Clarification No.1

Tender Enquiry No. PROC/LE/PT/P&P-18305/21

Description: Cooling tower pumps

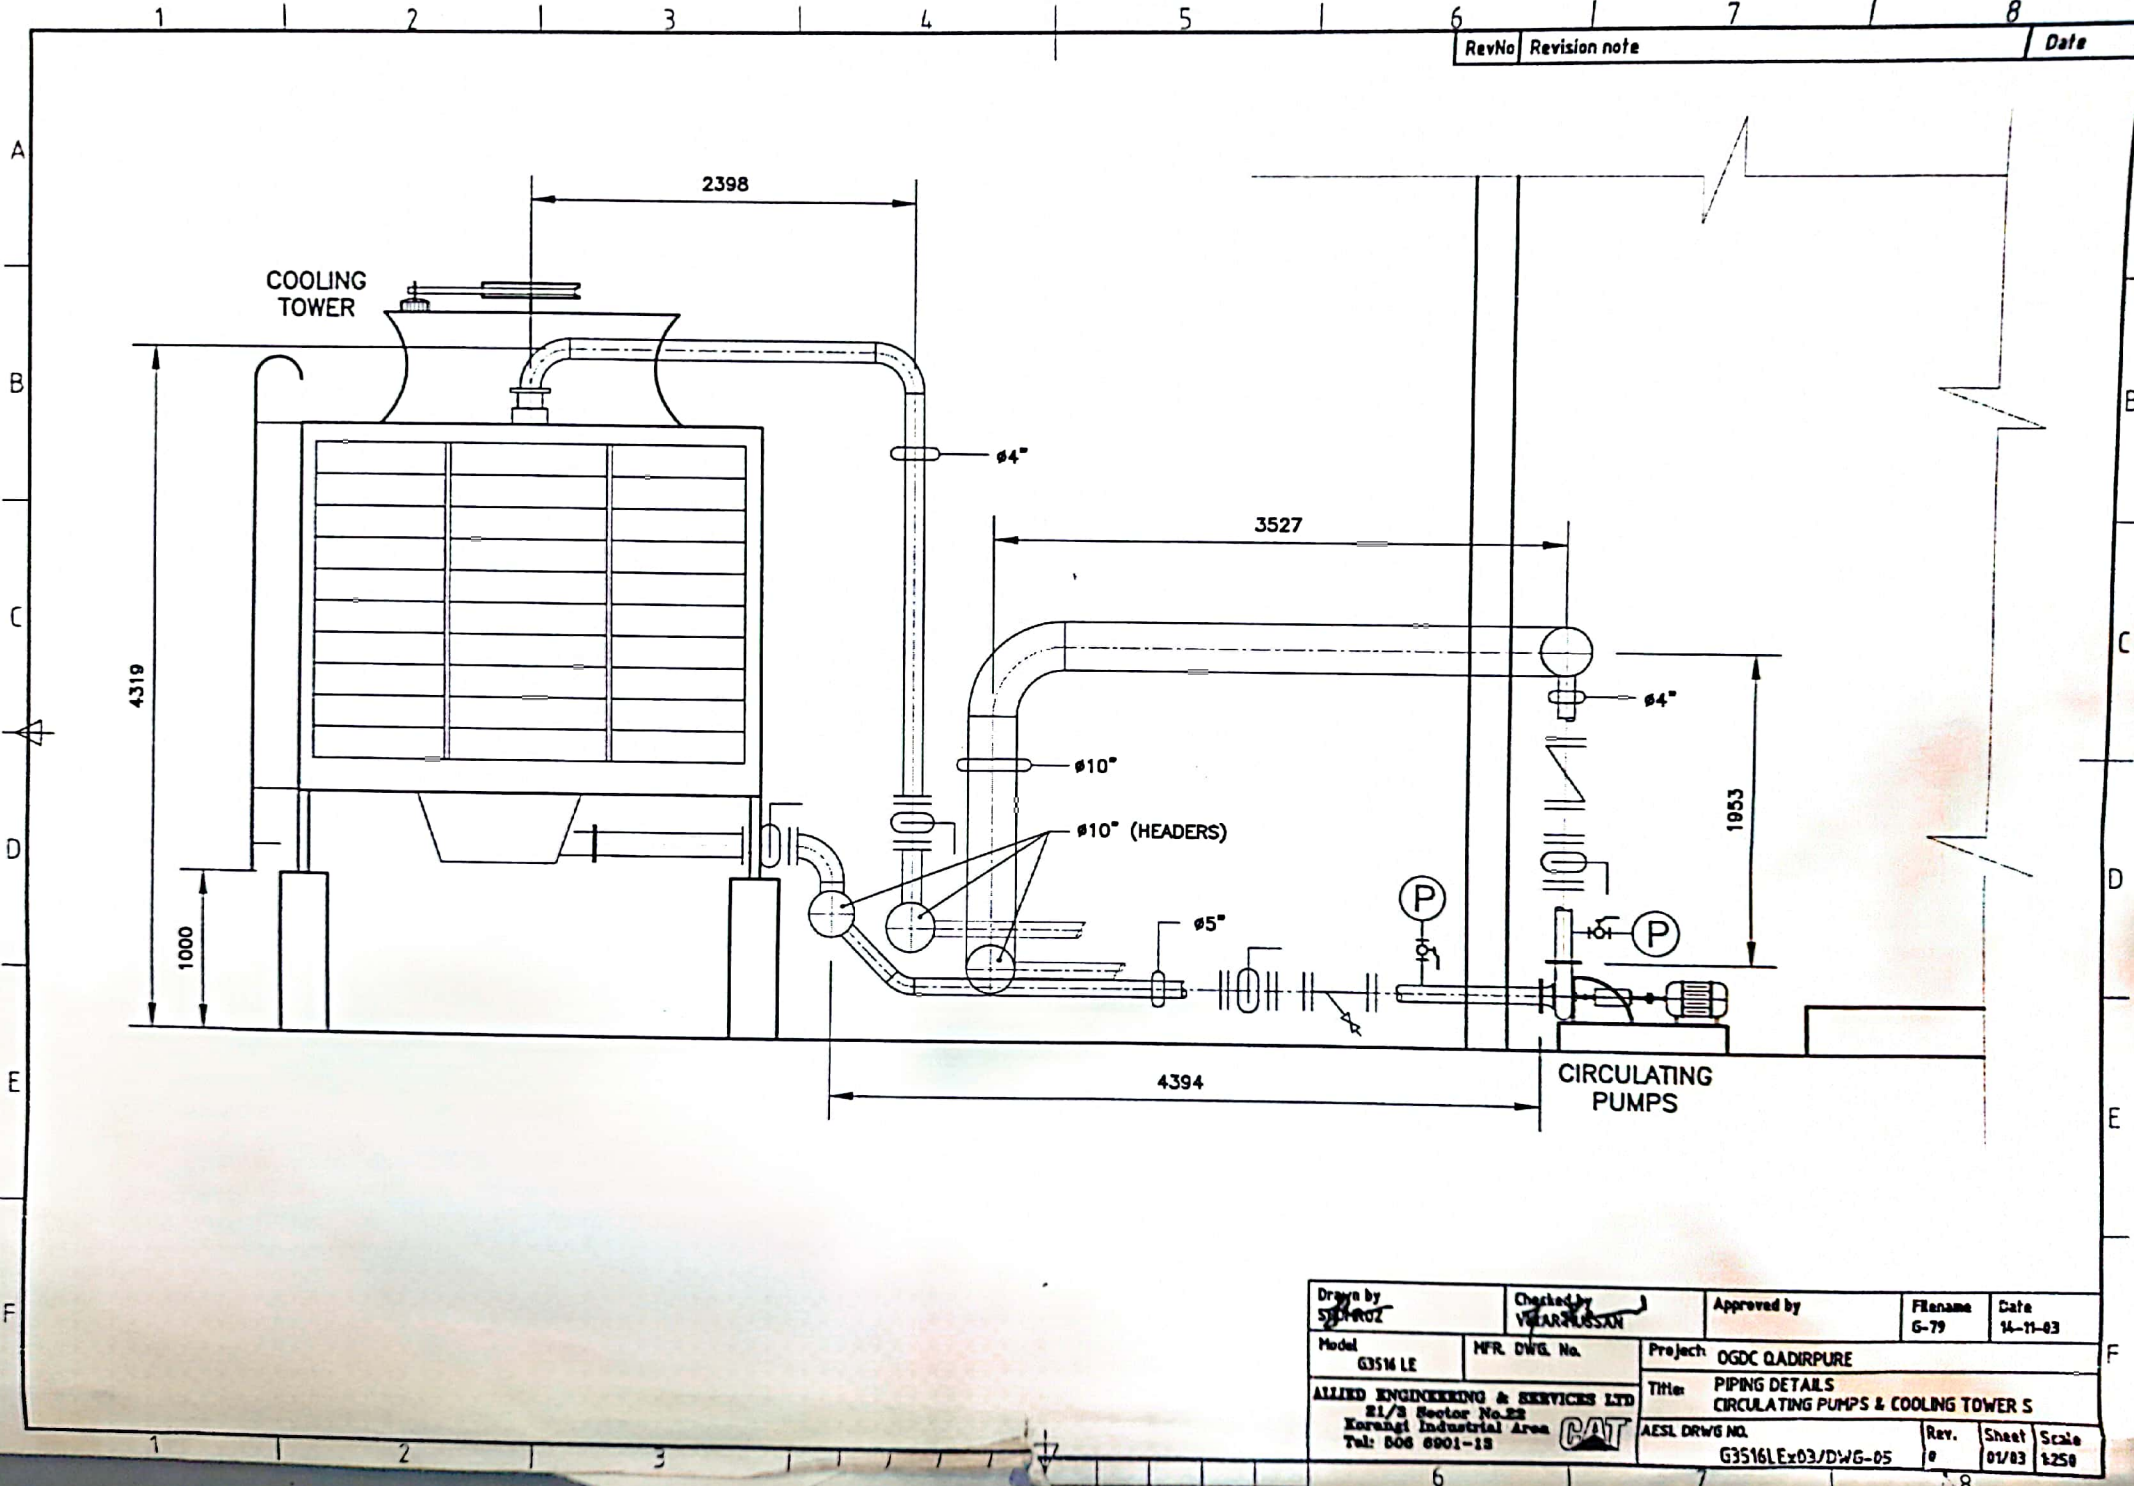
Sr.#	Queries	Reply
01	Tender documents mention that NPSH Available is 3.75 ft and suction pressure is atmospheric. Kindly note that the 3.75 ft equates to suction pressure of -0.86 bar.g, which is too low for the said application. You are requested to please recheck the NPSH Available at your end. Alternatively, OGDCL may share the rated suction pressure for selection purposes.	NPSH=37.5ft of water
02	Specifications for Motor in tender mentions motor with 415 V. As per our previous supplies, we have usually supplied motors with voltage of 400 V. Kindly confirm the requirement of voltage for motors, allowing us to proceed further accordingly.	Motors with voltage of 400 V level is acceptable
03	Suction is positive or negative (+ive if water source is above pump inlet, -ive if water source is below pump inlet)	Suction is positive
04	Horizontal pipe line length & diameter from water tank to pump inlet	Horizontal pipe length = 4394mm, dia 5"

05	Vertical pipe line length & diameter from water tank to pump inlet	Vertical pipe length 1953 mm, dia 4"
06	No. of bend in suction line	45 degree bend 01 nos in suction line.
07	Complete installation drawings of pumps	Attached here with
